TECHNICAL NOTE

**TRUE ADVANCED PURGE™ MODEL TAP-G3
RECENT ISSUES AND RESOLUTIONS**

**Model TAP-G3 Display Screen
Shown In ACTIVE DRIFT CONTROL™ Mode**

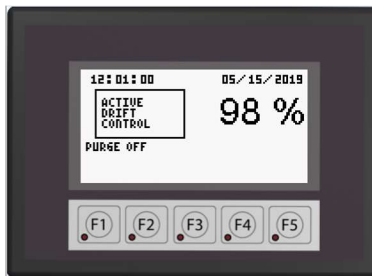
Issue – During the nightly automatic drift control (ADC™) procedure, users monitoring the **Model TAP-G3** fault contacts with a BMS or fire alarm system were receiving fault signals considered a nuisance when there was no actual fault.

Resolution – **UNITED Fire Systems** has updated the **Model TAP-G3** firmware to disable operation of fault contacts K1 and K2 during ADC™. Normal operation of the contacts is re-enabled after the automatic procedure is complete. The following table appears in Manual P/N 33-TG3MAN-000 Revision 1.01 on Page 9.

Model TAP-G3 devices manufactured on and after 11 Mar 2024 will be factory-programmed with this updated firmware. Devices manufactured before that date can be field-updated by **UNITED Fire Systems** for users requiring this feature. Contact **UNITED Fire Systems** for service.

MODEL TAP-G3
INLET PORT

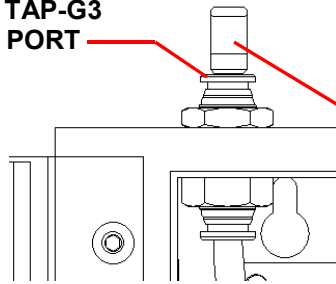
Issue – Installers have observed on occasion that debris has entered the sensor chamber of some **Model TAP-G3** devices. **UNITED Fire Systems** believes such debris entered the devices during installation. While the debris at this time has not resulted in inaccurate nitrogen purity readings or premature sensor failure, **UNITED Fire Systems** believes the entry of debris should be prevented.

Resolution 1 – To avoid debris entry directly into the **Model TAP-G3** inlet port, **UNITED Fire Systems** now installs a plug into the port at the time of assembly.

Keep the factory-installed plug in the port throughout and after the installation process. Remove the plug only immediately before attaching the sampling tubing to the port. Discard the plug after removal.

PLUG – REMOVE JUST PRIOR TO
ATTACHMENT OF TUBING

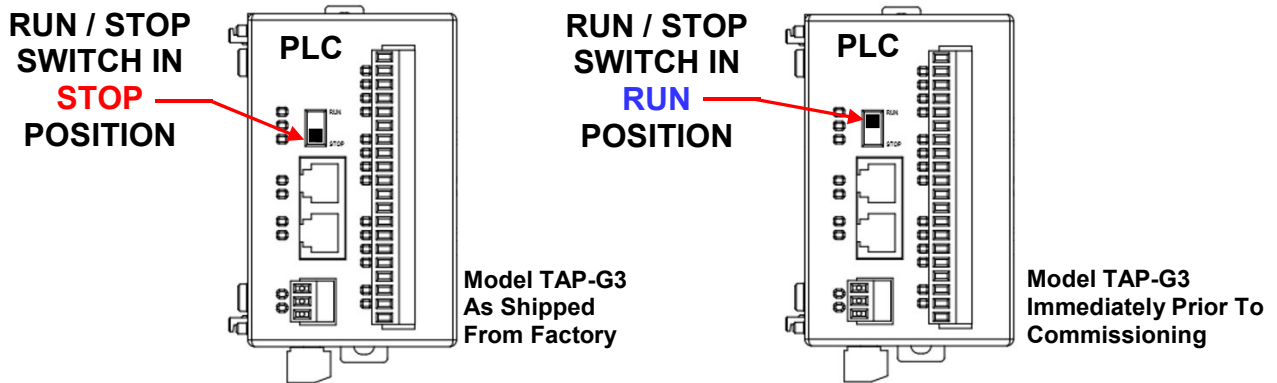
Issue – Several users have observed that their **Model TAP-G3** HMI (Human-Machine Interface) screen has turned a pinkish hue. **UNITED Fire Systems** has determined that this phenomenon occurs when the **RED** flashing of the screen during a fault has been allowed to continue for a very extended period of time.

Resolution 1 – Up to now, connecting live 115 VAC power to the **Model TAP-G3** device far in advance of commissioning has resulted in **RED** flashing for a long period. To prevent this flashing, **UNITED Fire Systems** is now leaving the PLC (Programmable Logic Controller) in **STOP** mode after factory testing.

Place the PLC **RUN / STOP** switch into the **RUN** position **ONLY** immediately prior to commissioning.
